**NEW MILLENNIUM PROJECT CONFIGURATION CHANGE REQUEST**

<b>PROGRAM</b> <u>EO-1</u> <b>CCR NO.</b> 0037 <b>DATE INITIATED</b> 07/14/99		<b>TITLE</b> CHANGES TO EO-1ALI TO S/C RS-422 DATA ICD-056 <b>ORIGINATOR</b> George Jackson <b>ORIGINATOR'S CHG. NO.</b>	
		<b>SPONSOR/CODE</b> George Jackson	<b>PHONE</b> x3255
<b>EFFECTIVITY</b> ITEM: <u>EO-1</u> S / N _____  ITEM: _____ S / N _____  ITEM: _____ S / N _____		<b>CHANGE CLASS</b>	
		<div style="display: flex; justify-content: space-around;"> <span>I</span> <span>II</span> </div>	
		<div style="display: flex; justify-content: space-between;"> <div> <b>PRELIMINARY</b> <input type="checkbox"/> <input type="checkbox"/>  <b>FORMAL</b> <input type="checkbox"/> <input type="checkbox"/> </div> <div> <b>TYPE OF CHANGE</b>  <b>MILESTONE</b> <input type="checkbox"/>  <b>DOCUMENT</b> <input checked="" type="checkbox"/>  <b>COST</b> <input type="checkbox"/> </div> <div> <b>INTERFACE</b> <input type="checkbox"/>  <b>POWER</b> <input type="checkbox"/>  <b>WEIGHT</b> <input type="checkbox"/> </div> <div> <b>SOFTWARE</b> <input type="checkbox"/>  <b>OTHER</b> <input type="checkbox"/> </div> </div>

<b>DOCUMENTS OR SOFTWARE AFFECTED</b> EO-1ALI TO S

3. Change Figure 1-1 EO-1 Flight Data System Architecture

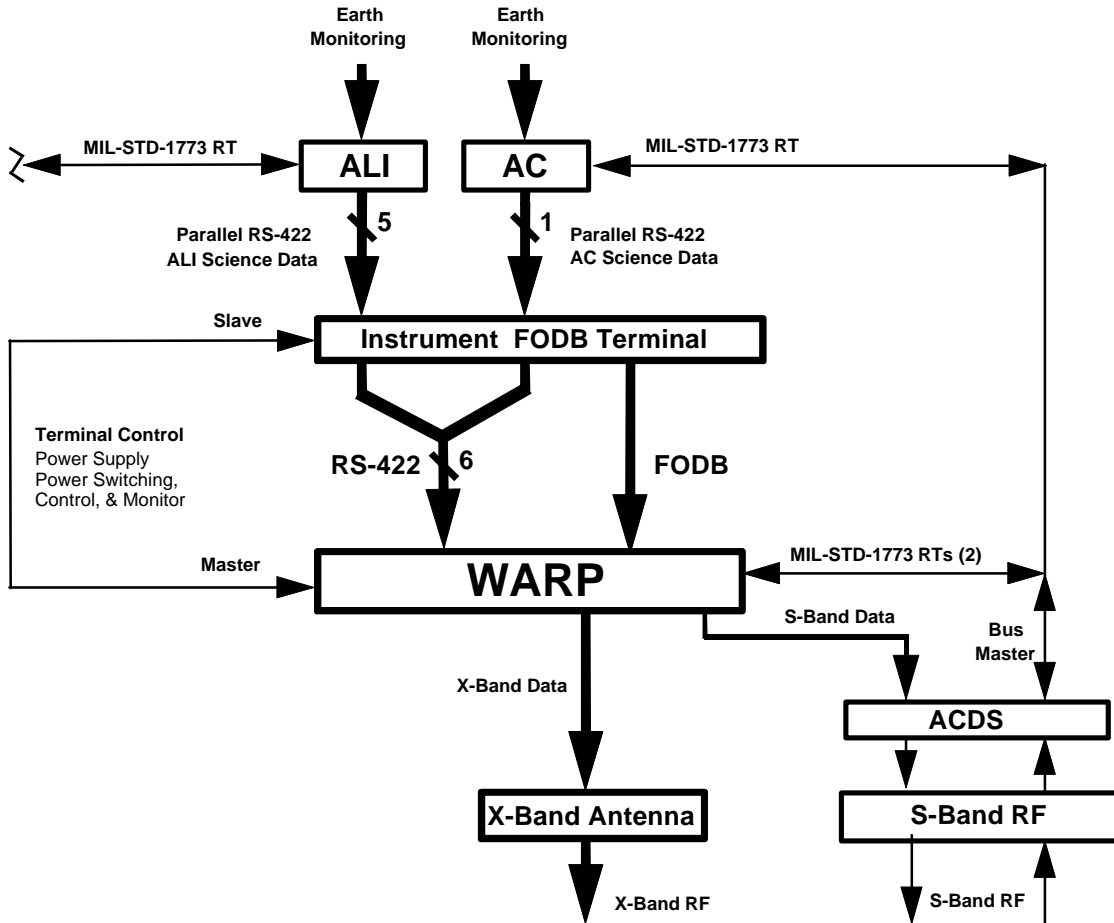
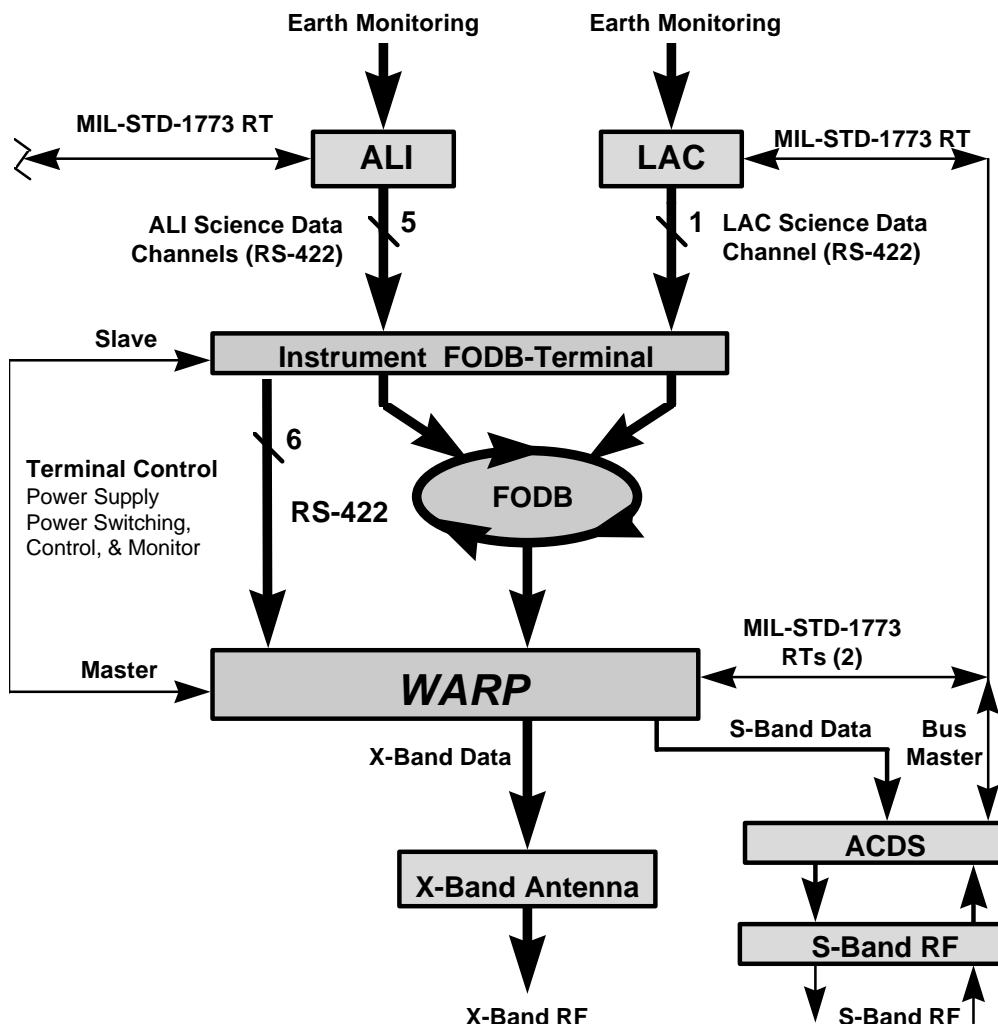
In change #3, the revised figure still includes the FODB and it's connections to the instruments. Though the figure is different than the original, it is apparently not updated to correspond to the text changes and should be reviewed by the preparer.

##### 5. Change Figure 1-2 ALI RS-422 Interfaces:

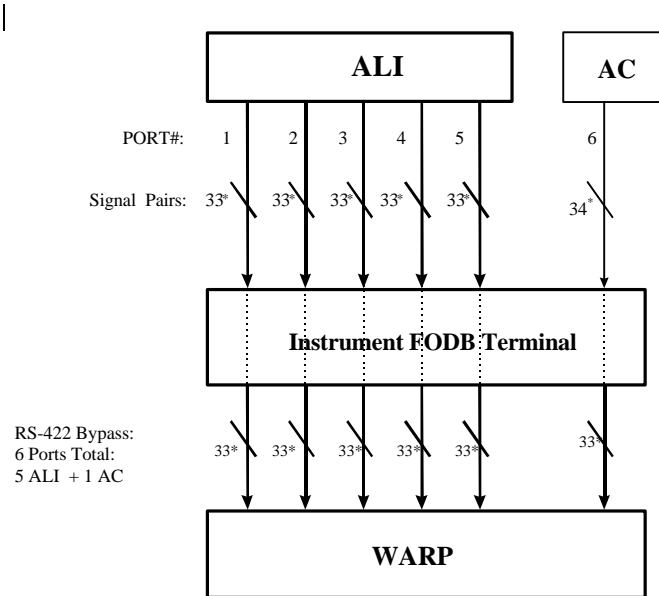
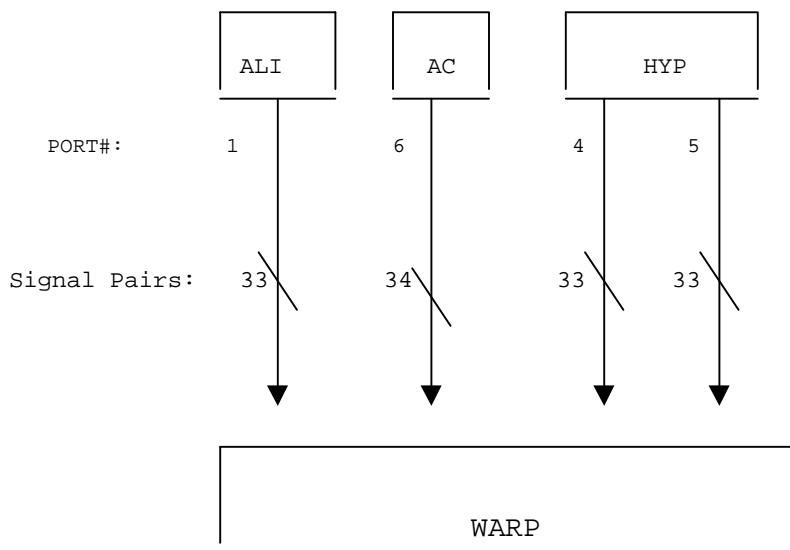
PORT 1 => MS/PAN (ALI PORT A)      PORT 4 => VNIR ~~HYP GIS~~ (ALI PORT D)  
~~PORT 2 => VNIR WIS (ALI PORT B)~~      PORT 5 => SWIR ~~HYP GIS~~ (ALI PORT E)  
~~PORT 3 => SWIR WIS (ALI PORT C)~~      PORT 6 ATMOSHPERIC CORRECRTOR (not defined here)
